**CITY OF SHERWOOD
JULY 5, 2022
STAFF REPORT**

**SHERWOOD BLVD. MULTIFAMILY
SITE PLAN REVIEW / CLASS A VARIANCE
LU 2022-006 SP / VAR**

To: Chair Jean Simson, City of Sherwood Planning Commission

From: Eric Rutledge, Associate Planner

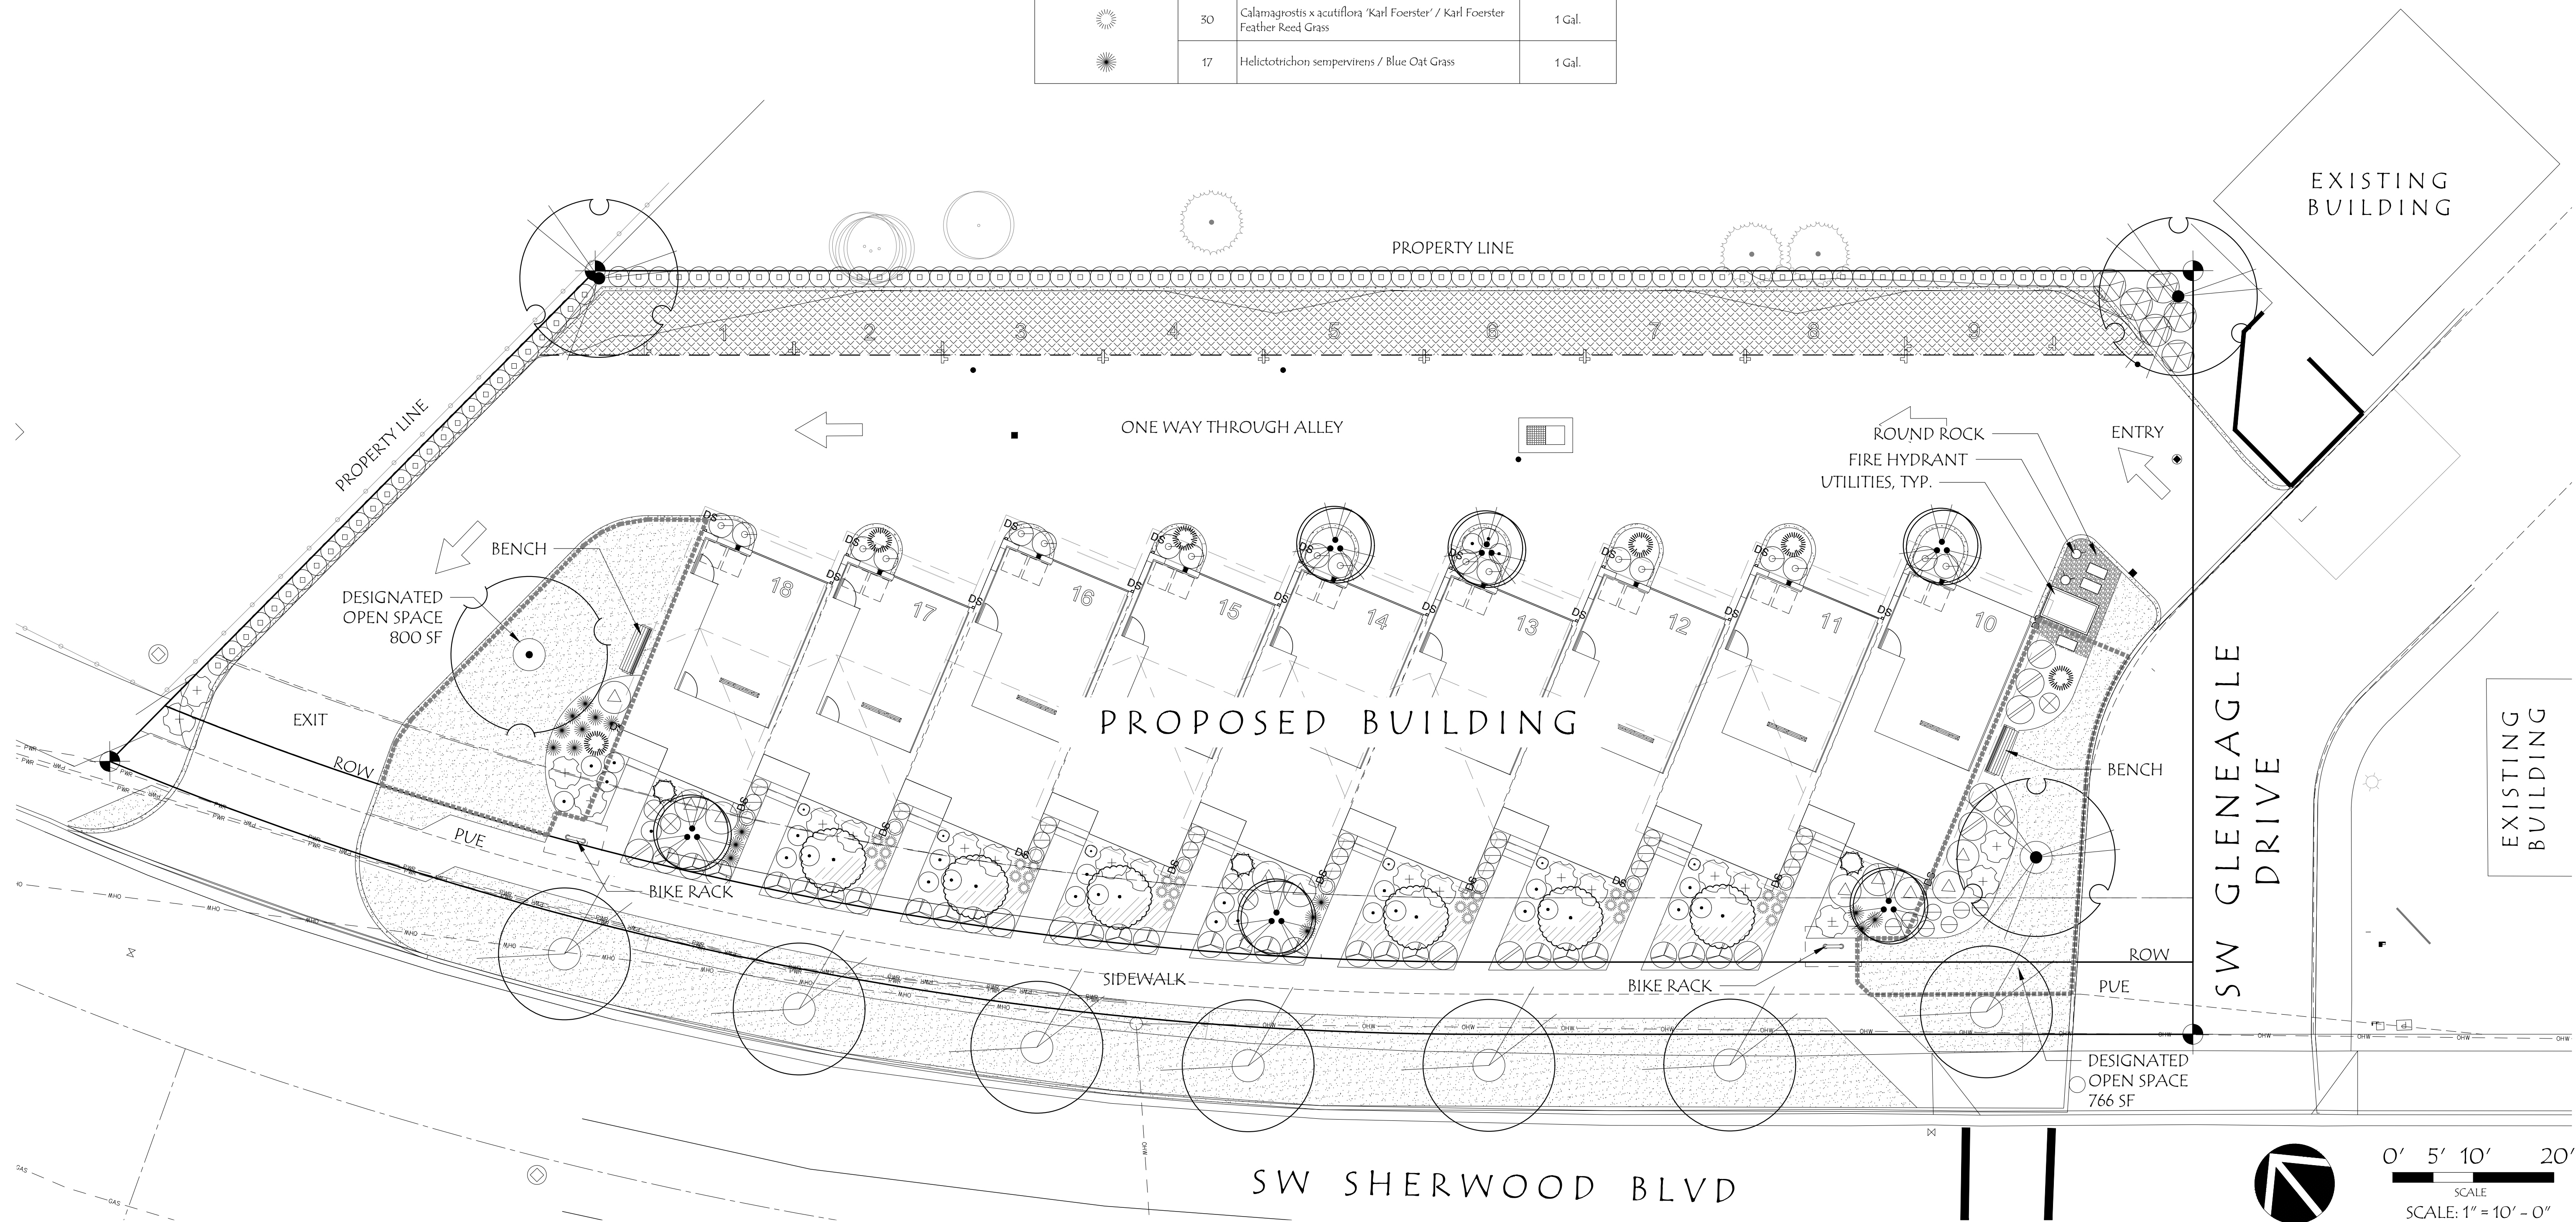
ANALYSIS: The applicant submitted a landscape plan (Exhibit A – Sub Exhibit C – Sheet L1.1) that shows the perimeter, parking lot, and site landscaping. Compliance with the specific landscaping standards is discussed below.

ANALYSIS: The total site area is 18,839 SF after the right-of-way dedication. The applicant is required to provide a 30% tree canopy which equates to 5,652 SF. Trees are proposed throughout the development site and within the right-of-way, equating to 5,751 SF of canopy (Exhibit A – Sub Exhibit C – Sheet L1.1).
